PCN 427

TRANSFORMER REPLACEMENT

DESCRIPTION AND SAFETY ANALYSIS
OF PROPOSED CHANGE NPF 10/15-427

This is a request to revise Technical Specification (TS) 3/4.8.1, "A. C. Sources," to allow a one-time exception for replacement of transformers B04X and B06X during the San Onofre Units 2 and 3 Cycle 7 refueling outages.

FIGURE 1

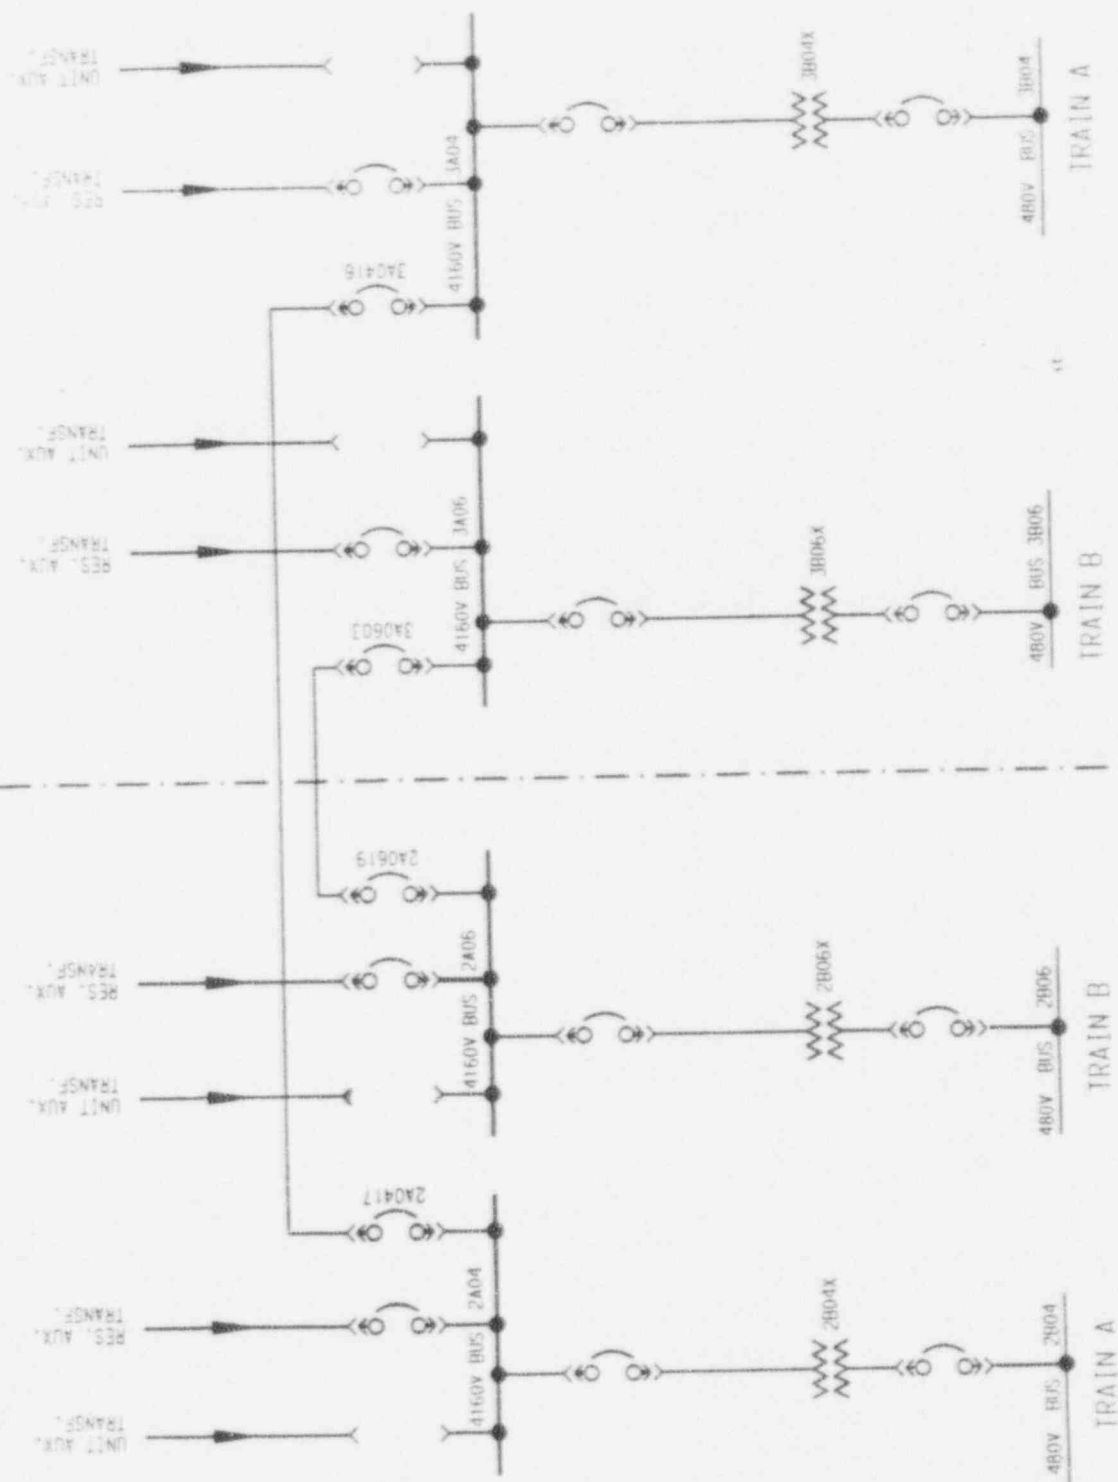
The cross-ties between the Units are at the 4kV level only. Transformers B04X and B06X are 4kV/480V and allow 480V loads to be connected to their own Unit's respective 4kV buses (2B04 to 2A04, 2B06 to 2A06, etc.).

During the upcoming Units 2 and 3 Cycle 7 refueling outages, SCE intends to replace the 480V load center transformers B04X and B06X. In accordance with SR 4.8.1.1.1.a, the Unit 2 load centers, including these transformers, are required to be OPERABLE for the Unit 3 cross-tie and vice versa. Therefore, during the Unit 2 Cycle 7 refueling outage, the replacement of load center transformers 2B04X and 2B06X will cause the cross-tie to Unit 3 to become INOPERABLE. The replacement work is expected to require approximately 120 hours per train to complete. TS 3.8.1.1 ACTION a.1 allows only 72 hours with one of the two A. C. sources unavailable before the unit must be shut down. Therefore, Unit 3 would also need to be shut down. This situation will be reversed during the Unit 3 Cycle 7 refueling outage.

This proposed change will add a footnote to SR 4.8.1.1.1.a for Units 2 and 3 to allow the tie breakers to remain OPERABLE with load centers B04 and B06 INOPERABLE because of the 480V transformer replacement during the opposite unit

Cycle 7 refueling outage. Although the Unit 3 SR currently is for tie breakers 2A0416 and 2A0603, the proposed footnote for Unit 3 lists tie breakers 2A0417 and 2A0619. This is because the SR currently lists the incorrect breakers. This will be corrected by PCN 363, which was submitted on November 25, 1991 (see Enclosure 2).
